# Addendum #1

**Project Name:** Highland Hills Pump Station Control Panel Procurement

**Bid Number:** F24-01-011

**Date:** March 25, 2024

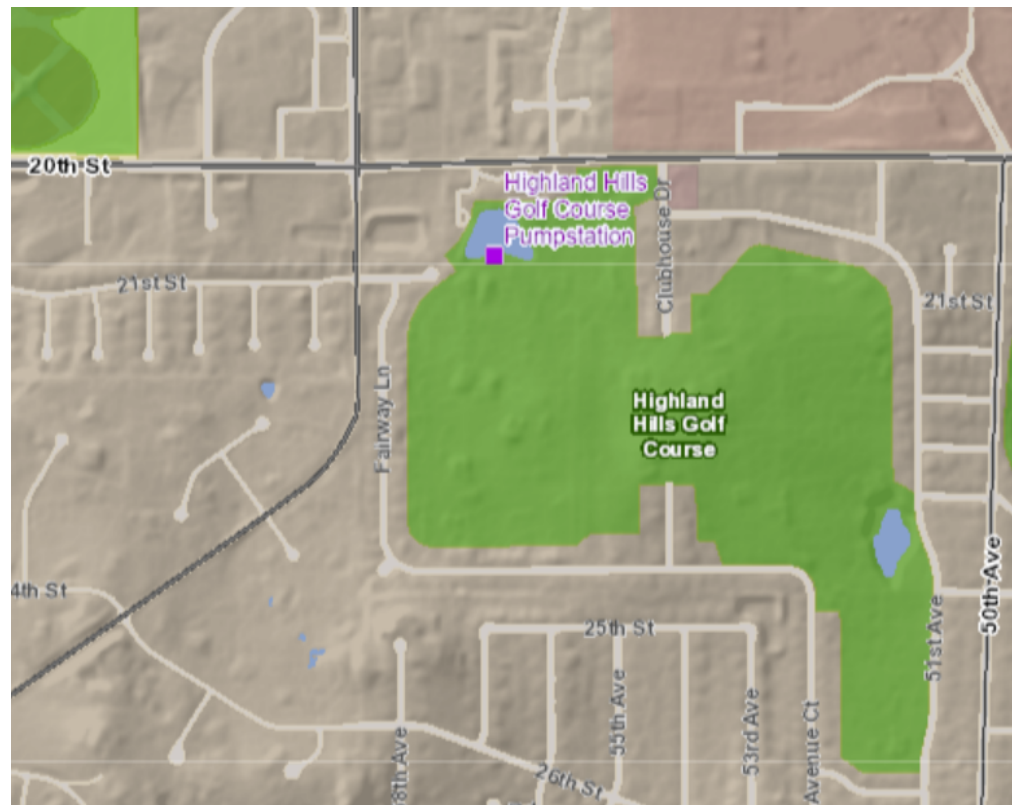
**Change #5** Change Exhibit 5, 2.3 B. by inserting the following, "4. Or approved equal."

**Explanation** Change allows other Vendors to submit a proposal to this RFP.
